Response to Biodiversity Conservation Division
advice on Response to Submission report

Valley of the Winds – Response to BCS Advice on RtS

ACEN Australia

Figure 1: Metmast locations

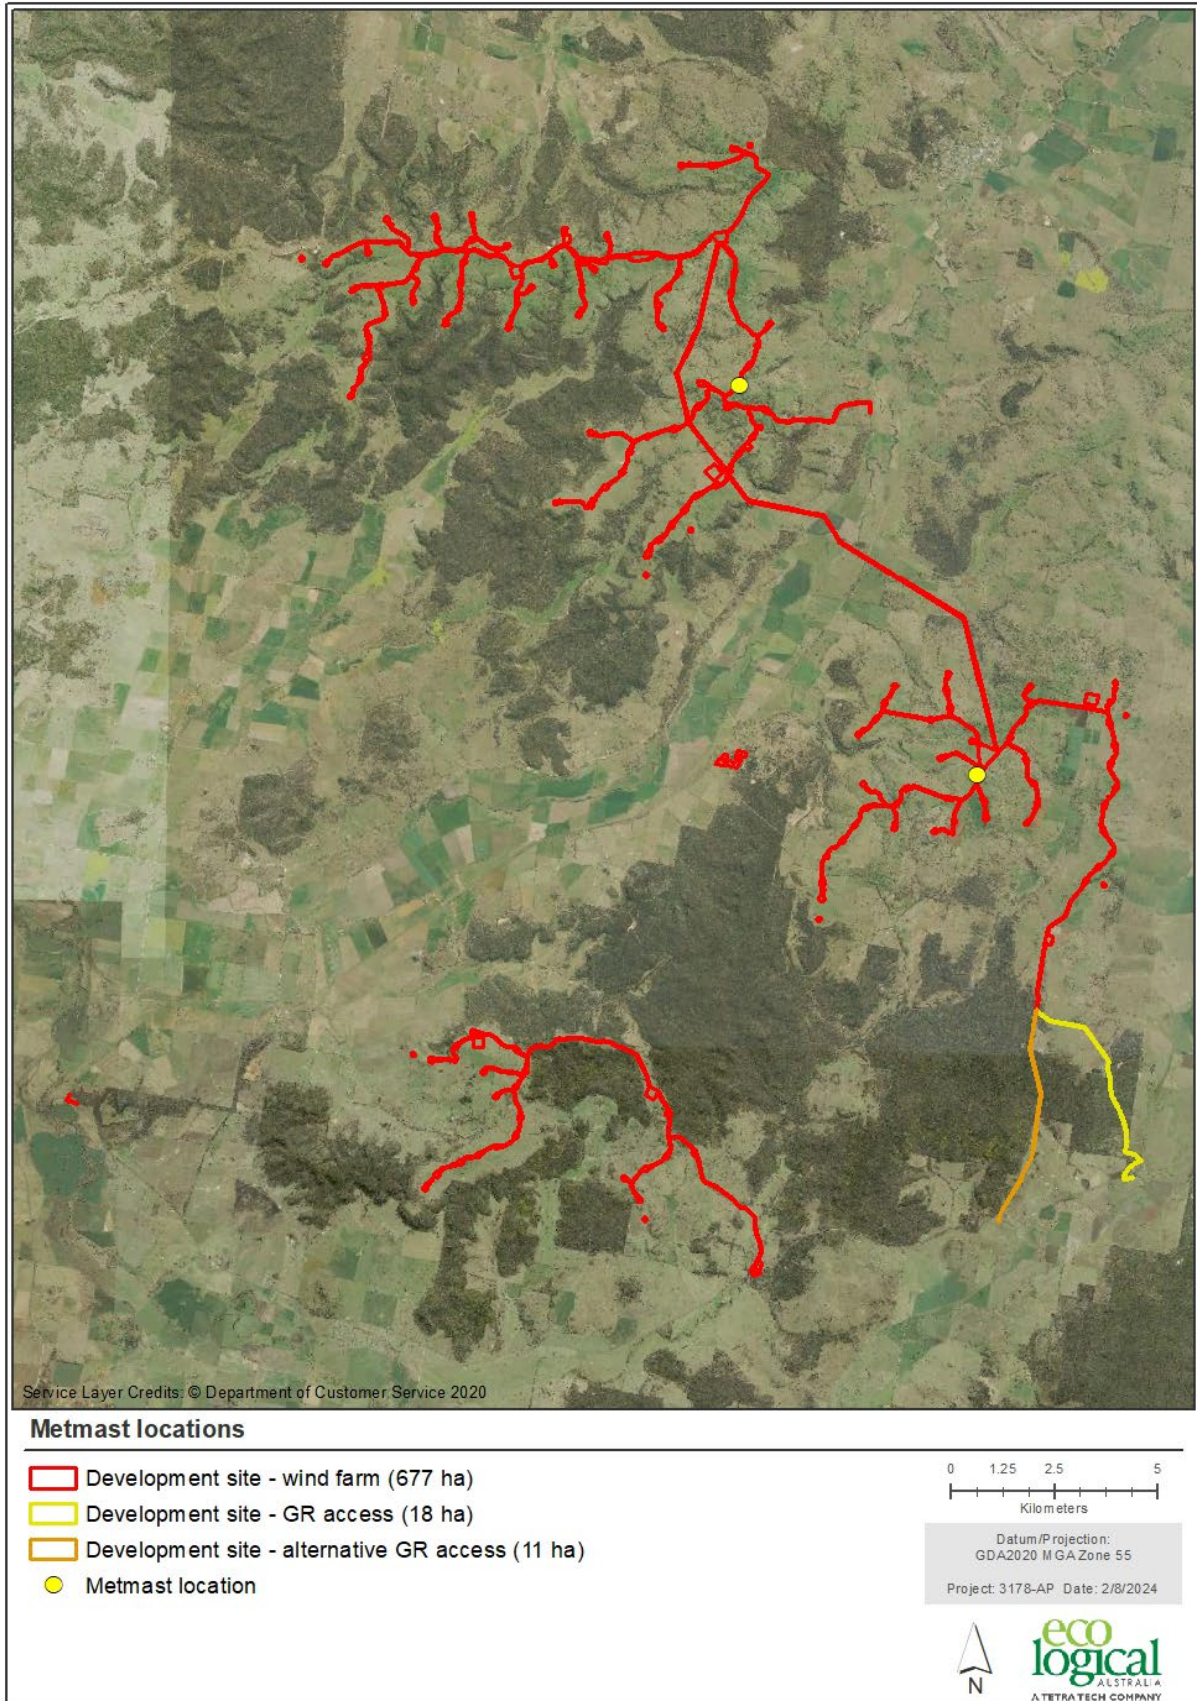
1.3 Provide the locations of the current meteorological masts in the BDAR and spatial data and justify the exclusion of the 'SM Wombat' songmeter in the BDAR

A map of the locations of the two current metmasts is shown in Figure 1.

ELA has collected sufficient data in accordance with the 'Species credit' threatened bats and their habitats NSW survey guide for the Biodiversity Assessment Method (OEH, 2018). SM Wombat was set in a location outside of any potential breeding habitat, and as such will not change the outcome of the BDAR. ELA notes that this unit has not contributed to the total survey effort undertaken as described in Table 1. No further analysis will be undertaken with this data at this time.

Figure 3: Diuris tricolor predicted PCTs - Survey effort in suitable season

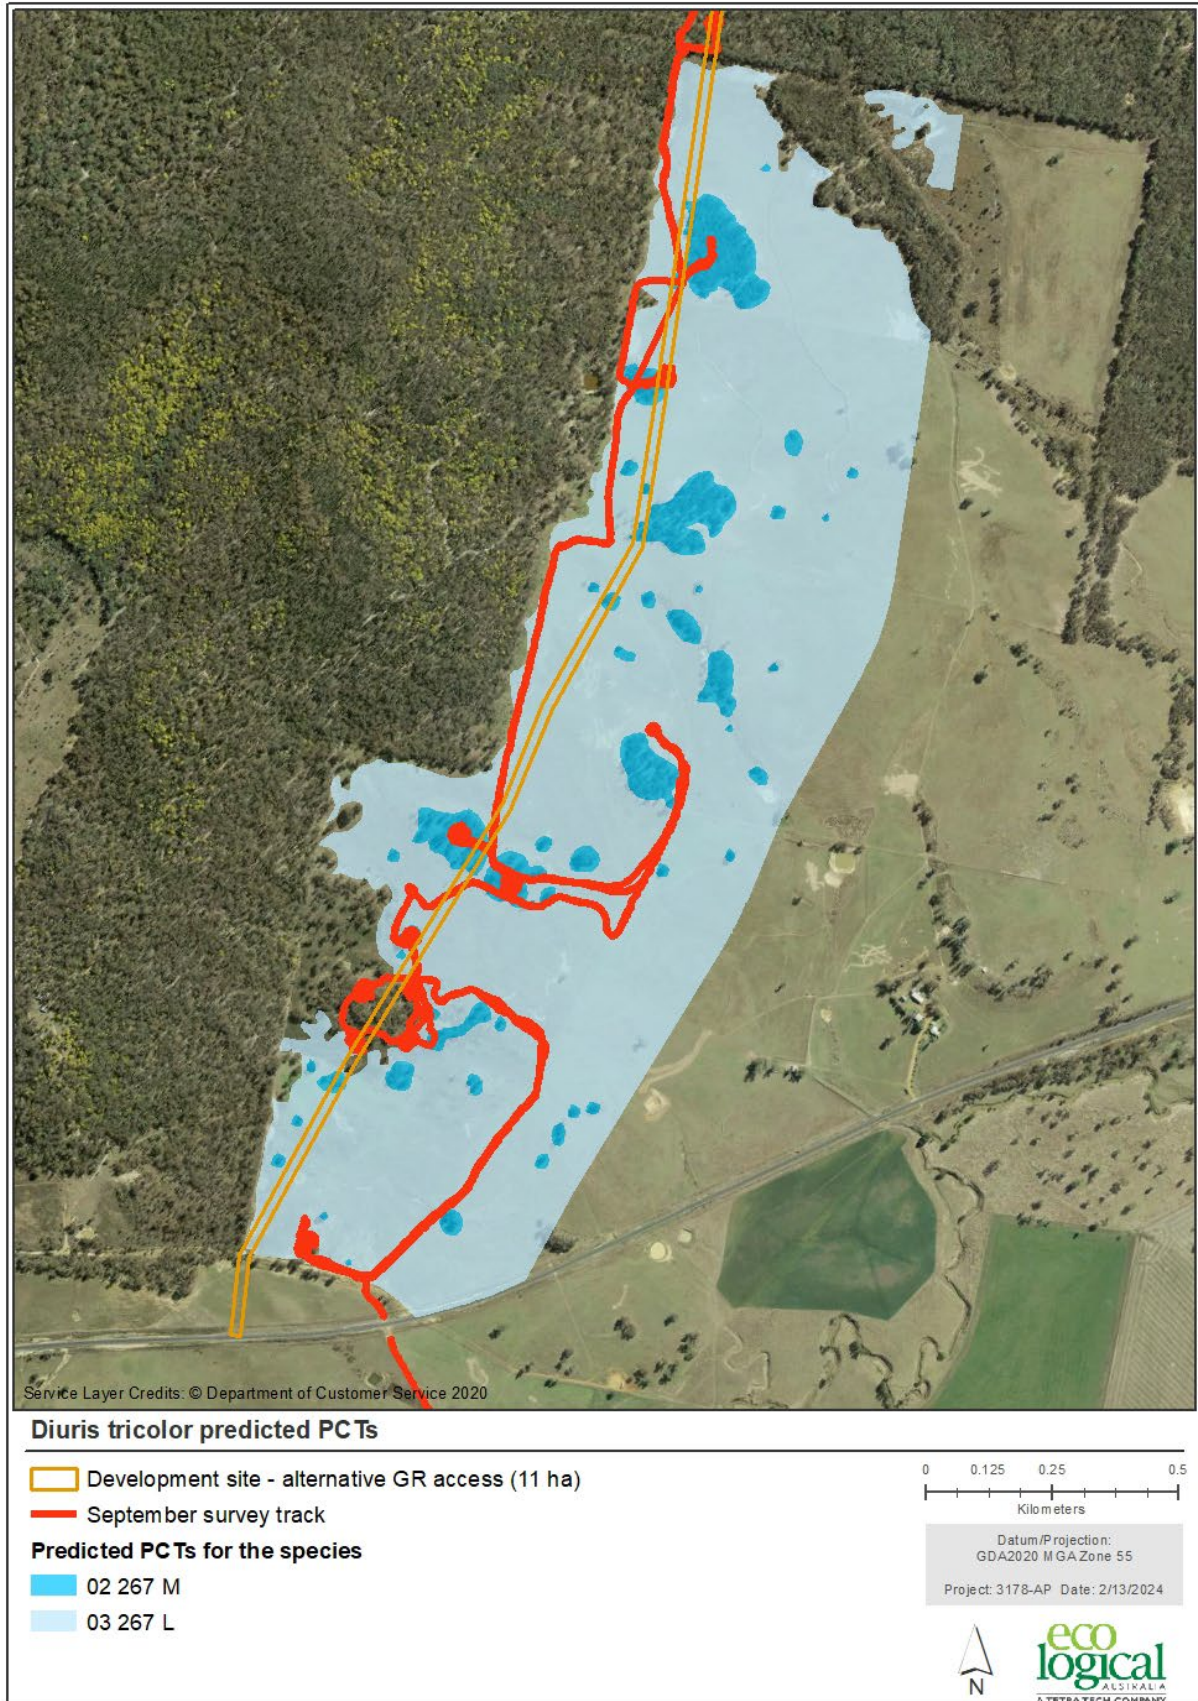
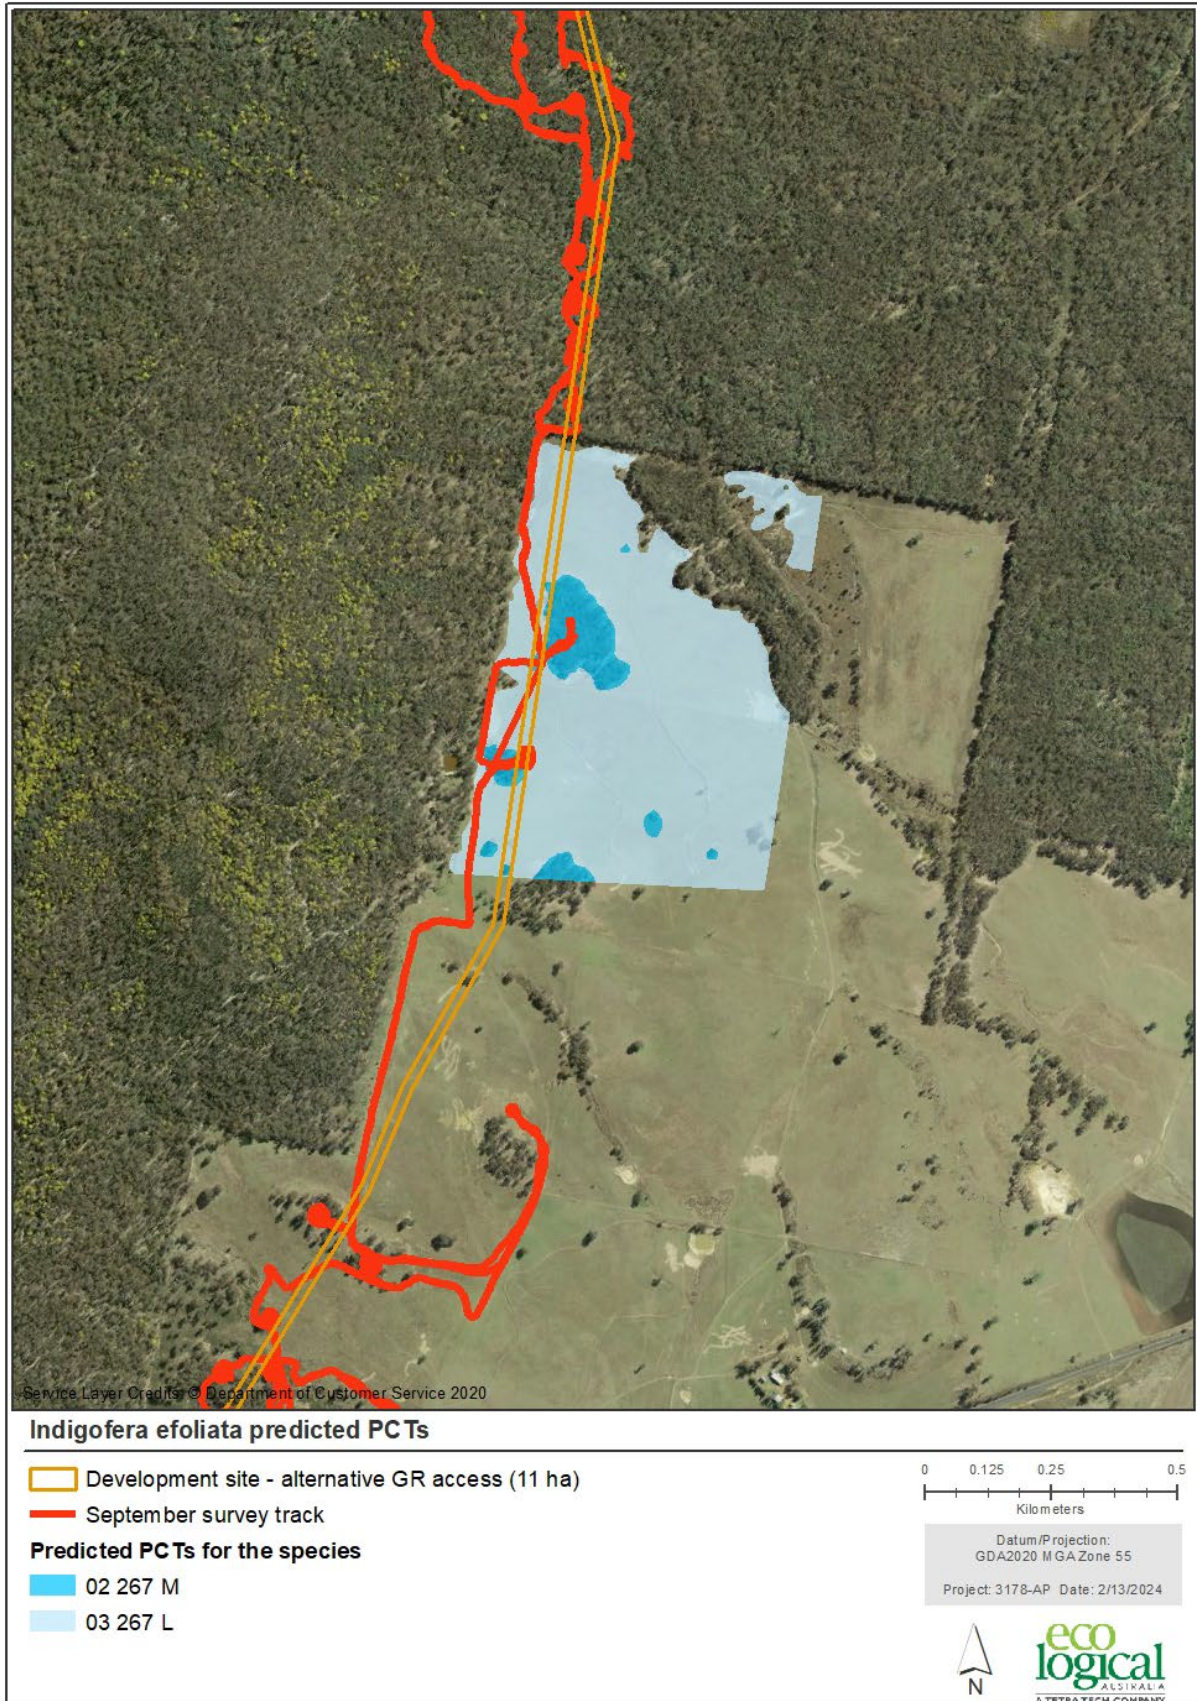
9.1 Provide further justification for the exclusion of candidate threatened species in each of the BAM-C cases, in accordance with section 5.2.2 of the BAM.

Notwithstanding the site condition, ELA ecologists surveyed a grid pattern across the development site, within PCT267, in September 2021. This survey included targeted searches within the best areas of habitat, during the appropriate season. The location of survey is shown in Figure 3 and Figure 4. Neither species was identified, and both have been selected as surveyed – no in the BAM-C. As such, no further assessment is deemed required.
